AMENDMENTS TO THE DRAWINGS/FIGURES

REMARKS

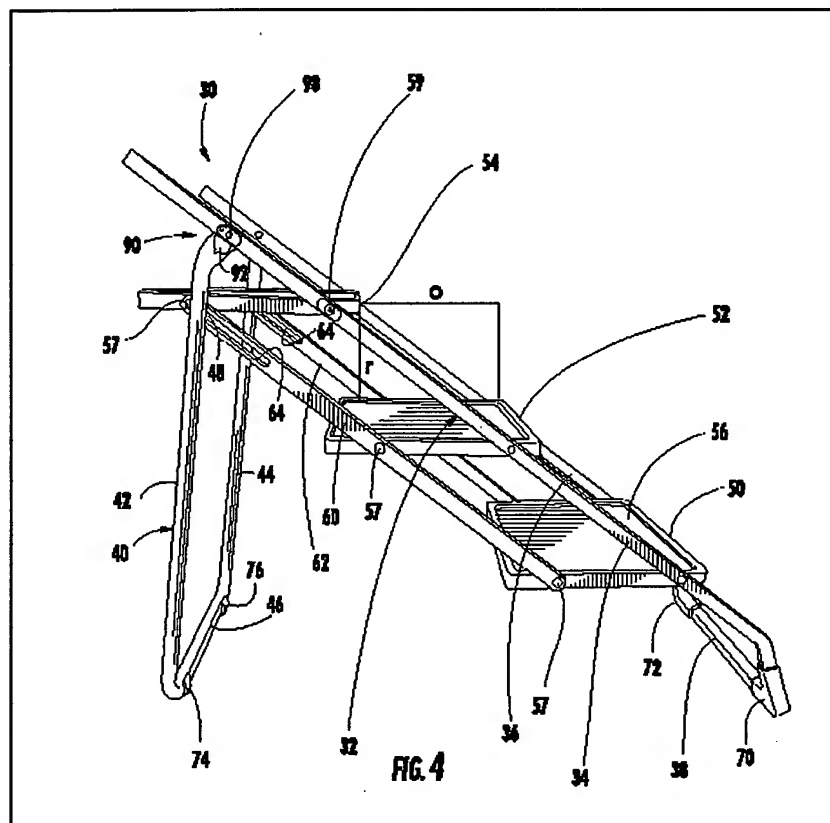
As a preliminary matter, the applicants submit herewith amendments to the specification that include changes to reference numerals such that all reference numerals refer to only one element. As amended, reference numeral 33 refers to the U-shaped angled forward frame member, reference numeral 38 refers to the base member of element 33, and reference numeral 36 refers to a leg of element 33.

As a further preliminary matter, the applicant has included a proposed drawing change for Fig. 4. Particularly, the applicant proposes that in Fig. 4 reference numeral 34 be changed to 33 to be consistent with amendments to the specification. Prior to amendment, this reference numeral was inadvertently used twice. No new matter has been added.

Figs. 1 and 4 of *Lister* are reproduced below for convenience.

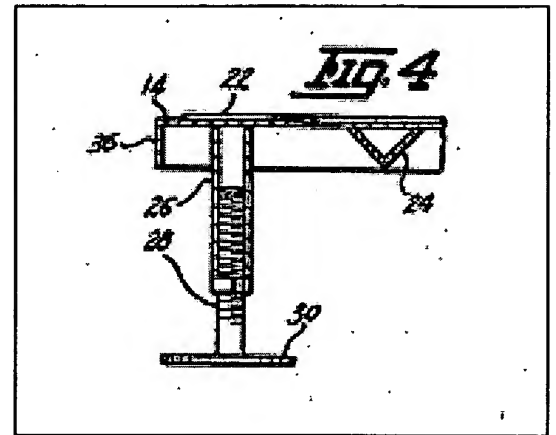
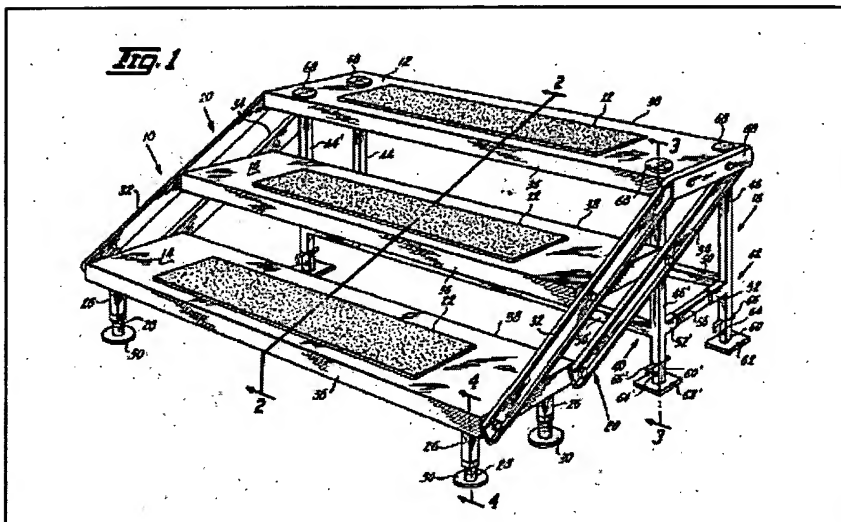
The Examiner also rejects claims 16-23 and 25 under 35 U.S.C. §102(b) as being anticipated by U.S. Pat. No. 3,593,821 to *Lister*. *Lister* does not disclose an angled forward frame portion including two spaced legs connected by a base member. Element 36 of *Lister* is not a base member connecting the two legs of the forward member. Instead, element 36 is the

forward edge of the bottom step. See *Lister*, column 3, lines 47-49.

Additionally, a base member connecting the legs of *Lister* would destroy one of the

main functions of *Lister*, namely, the ability to adjust the height of the system from the bottom.
